## Agenda Item # 3 SUB-002698-2023

Williams Willow Subdivision, Resubdivision of Lots 6 &  
7

WILLIAMS WILLOW SUBDIVISION,  
RESUBDIVISION OF LOTS 6 & 7

APPLICATION NUMBER 3 DATE November 16, 2023

# SITE PLAN

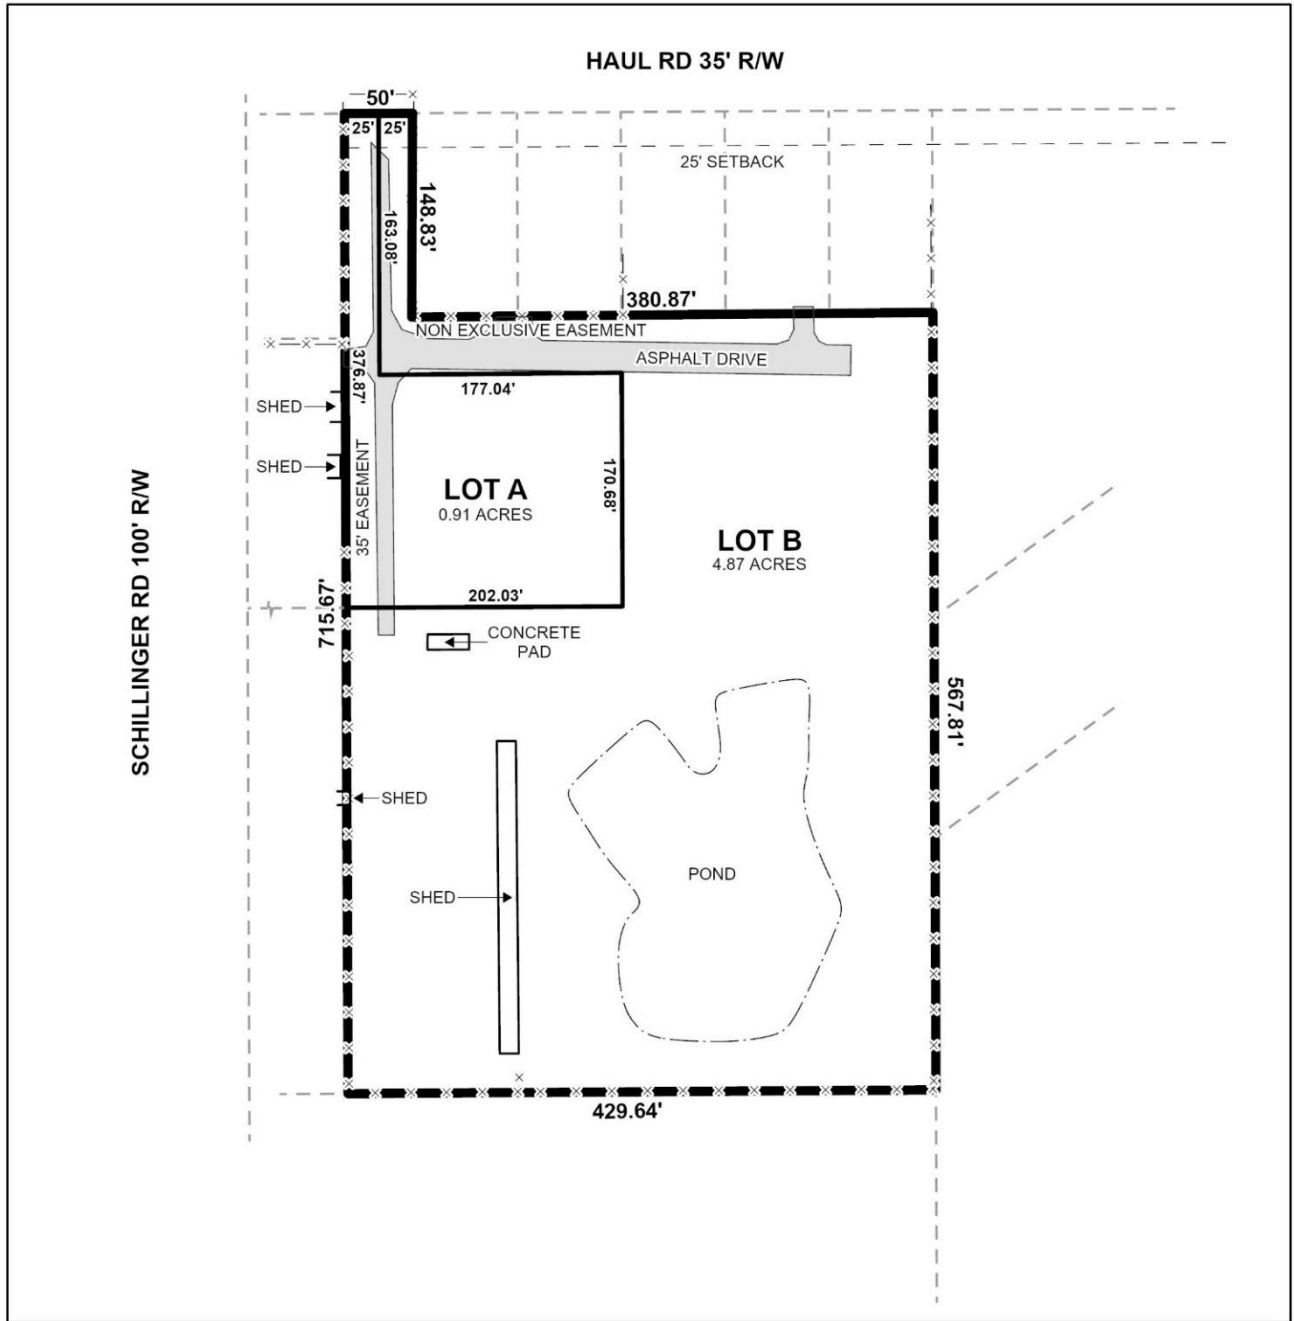
Both Lot A and Lot B have proposed frontage on Haul Road, a recently annexed minor road without curb and gutter requiring a 60-foot right-of-way. The preliminary plat illustrates Haul Road as an unimproved gravel road with sub-standard 35-foot right-of-way. If approved, the plat should be revised to illustrate dedication sufficient to provide 30 feet from the centerline of Haul Road.

The Preliminary Plat depicts both Lots A and B as irregular, flag-shaped lots. Per Section 6.C.9. of the Subdivision Regulations, flag shaped lots are generally not allowed. There are existing flag-shaped lots in the vicinity of the site, a number of which were approved by the Planning Commission under various subdivision requests. However, these lots provided direct access to a paved road. If approved, a waiver of Section 6.C.9. will be required.

The Preliminary Plat illustrates a non-compliant minimum building setback line for both Lots A and B. If approved, the Final Plat should be revised to illustrate a minimum building setback line located 25 feet from the point where each lot "balloons" out to a minimum width of 60 feet.

The proposed lots exceed the minimum size requirements of Article 2, Section 64-2-16 of the UDC for lots in an R-1, Single-Family Residential Suburban District. However, neither proposed lot is appropriately labeled and as such, the preliminary plat should be revised to depict the lot size labels in both square feet and acres on the Final Plat; or a table should be furnished on the Final Plat providing the same information.

Both Lot A and Lot B contain non-exclusive access and utility easements; however, as illustrated the location of said easements are not clearly depicted. Therefore, the easements should be clearly illustrated on the Final Plat, if approved. Additionally, a note should be required on the Final Plat, if approved, stating that no structure may be constructed or placed within any easement without the permission of the easement holder.

1. Revision of the Final Plat to depict dedication sufficient to provide 30 feet from the centerline of Haul Road;
2. Revision of the Final Plat to illustrate the minimum building setback line for Lot A and Lot B to be located 25 feet from the point where each lot “balloons” out to a minimum width of 60 feet;

3. Revision of the Final Plat to depict lot size labels in both square feet and acres, or provision of a table on the Final Plat with the same information;

4. Revision of the Final Plat to clearly illustrate all easement locations;
5. Provision of a note on the Final Plat stating that no structure may be constructed or placed within any easement without the permission of the easement holder;

6. Provision of a note on the Final Plat stating that Lots A and B cannot be further resubdivided until such time that direct access to a compliant, fully improved roadway can be provided;
